A Joint Response to --- CPC2015-183

Proposed Amendment and Land Use Amendment, Chinatown (Ward 7)
Site1B located between 2nd / 3rd Avenue SW and 1st / Centre Street SW
- Chinatown Area Redevelopment Plan (ARP) (Bylaw 38P2015)
- Land Use Designation (Bylaw 179D2015)

2016 December 5

Calgary City Council Public Hearing

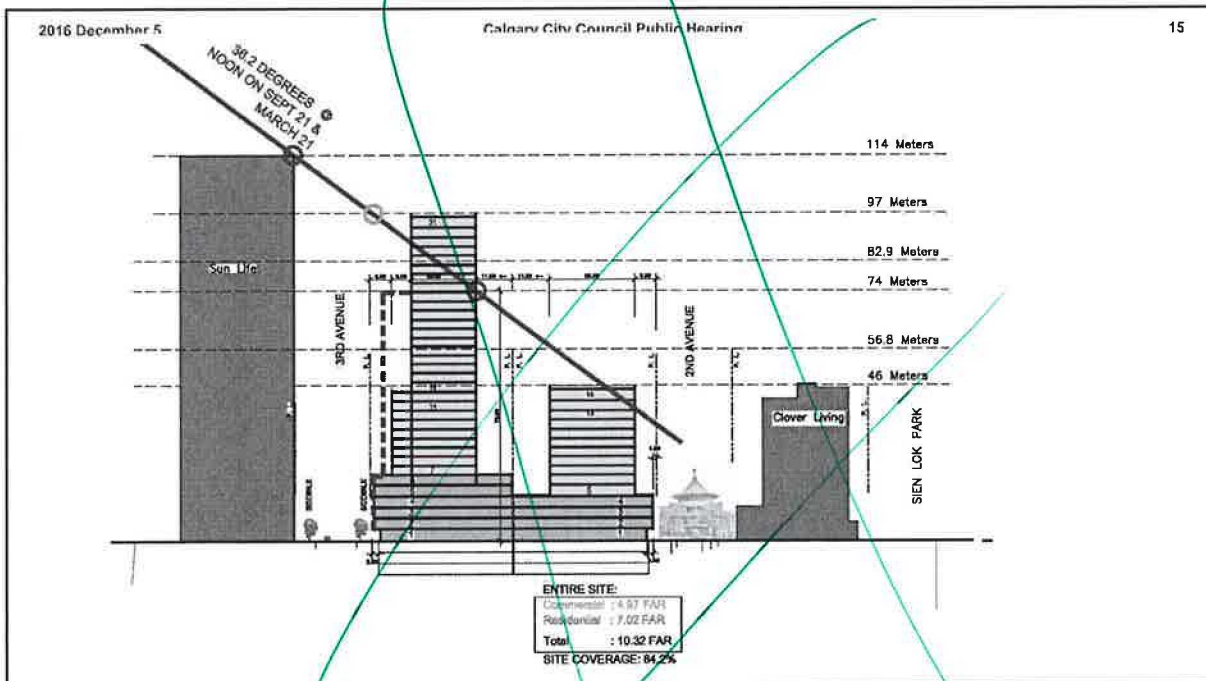
Regarding the Application Amendments

- **Strongly Oppose:**
 - 3rd Ave. 97M Building Height
 - 3rd Ave. 6 Storey Podium
 - we prefer 3 storey podium as per original Application

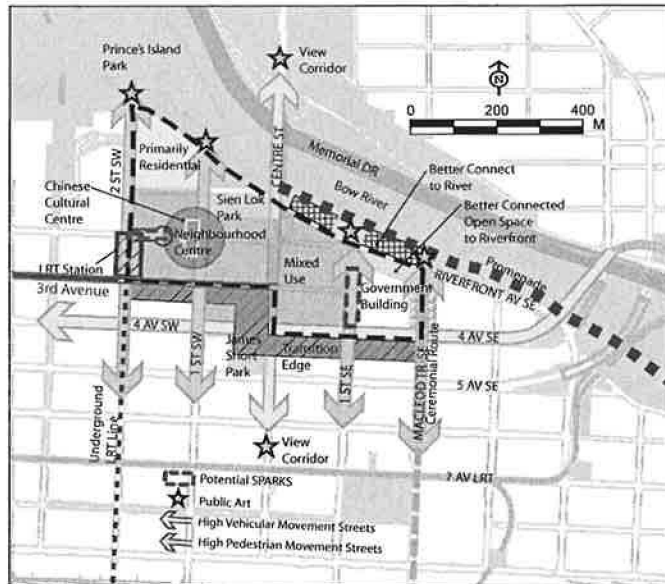
Regarding the Application Amendments

- **Strongly Oppose:**

- 12 FAR;
- Our concerns are reduced if the bylaw provides a minimum 60% residential component, lower building height and reasonable setbacks and stepbacks that preserves distinctive Chinatown streetscape that minimizes our massing concerns.

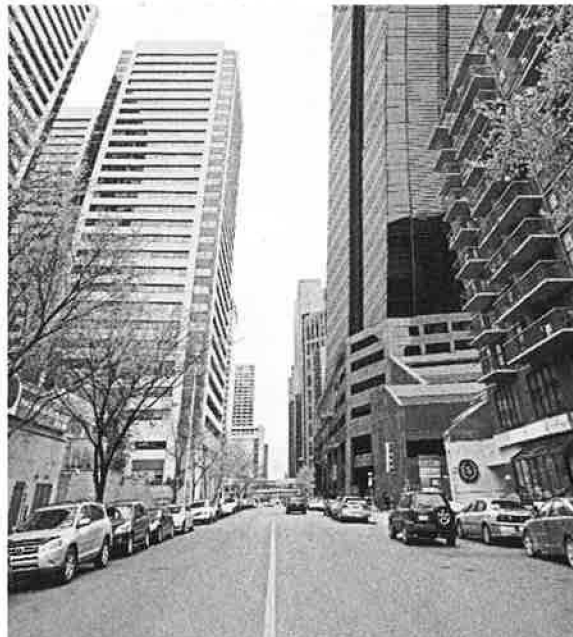
➤ **Centre City Plan**
recognizes transition
zone outside the
community boundary.
